# 1959 Corvette: Service Bulletin: Excessive Driveline Vibration

**Source:** General Motors of Canada Service Bulletin

**Date:** September 30, 1959

## EXCESSIVE DRIVE LINE VIBRATION - 1959 Corvette Models

Fig. 44.

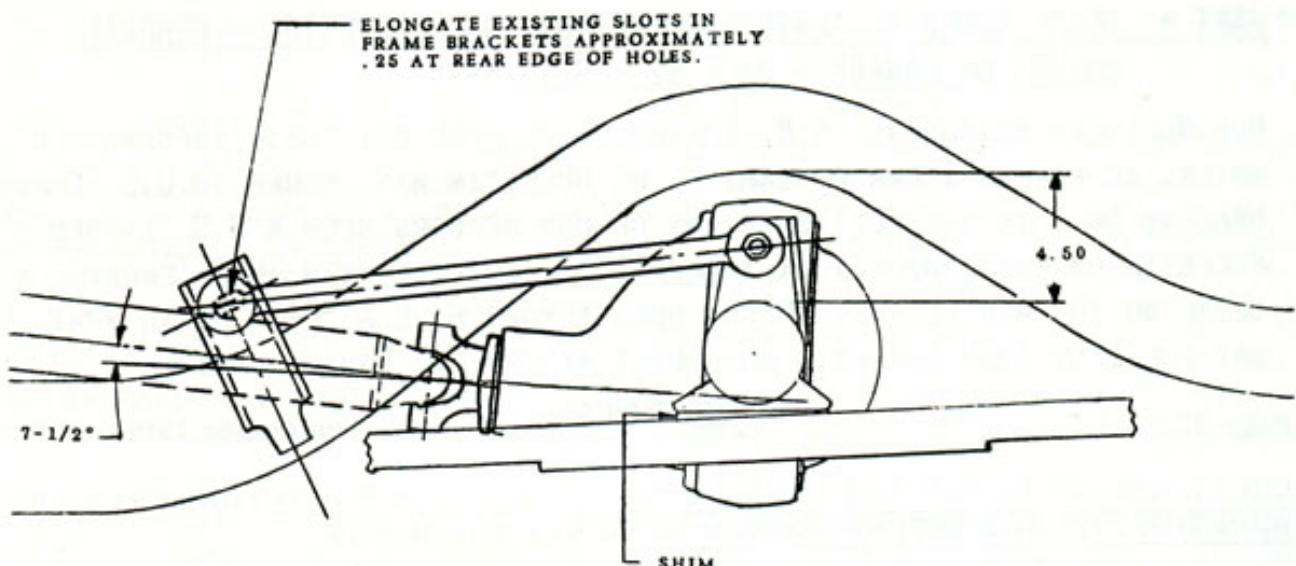
If excessive drive line vibration is encountered on the 1959 Corvette, it is probably due to excessive rear U-joint angle. Elimination of the vibration can be accomplished by installing either a 2° or 3° shim between the axle pads and springs on both sides, with the thick side to the front.

The nominal angle of the rear U-joint is 7-1/2°. Care should be taken in not going under 7-1/2° due to interference at full bump position.

2. The radius control rods should be disconnected before installing the shim. Before re-attaching the radius control rods, elongate the radius rod frame mounting hole 1/4" rearward if necessary to eliminate any interference between the radius control rods attaching bolt and mounting bracket. Shim part #3722797 (2°), or #3744488 (3°), or their equivalent may be utilized. The locating tab on the above shims should be removed to allow the shim to lie flat.

The propeller shaft and pinion angle and the elongation of the radius rode mounting bracket hole is shown in Fig. 44.
